# Technical Bulletin

## Our Trimmer Series PJ 11 - 63 and Volume Control PJ 85 Just got better!

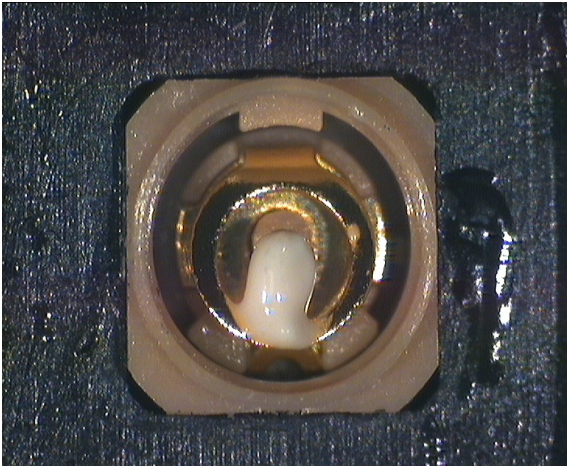
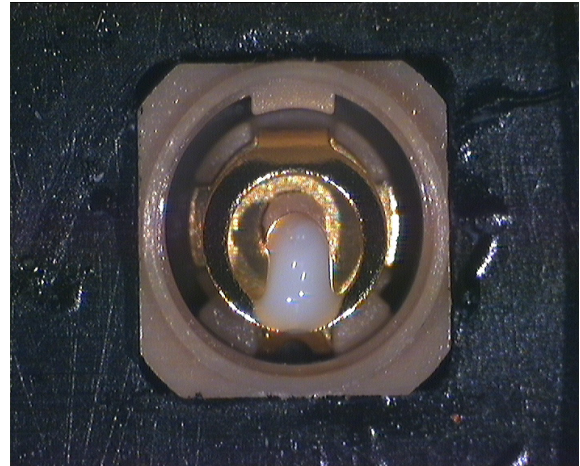
Therefore, we are pleased to announce that we have achieved a more reliable trimmer series and PJ 85 with our new and improved internal sealant. The sealant inside the trimmer and PJ 85 will provide more resistance to heat, solvents and cleaning agents used during handling.

The sealant can be identified from the inside of the component by its more whitish appearance. Please see pictures above. This change was implemented on June 6th, 2006 and will have no influence on the part numbers that you order today.
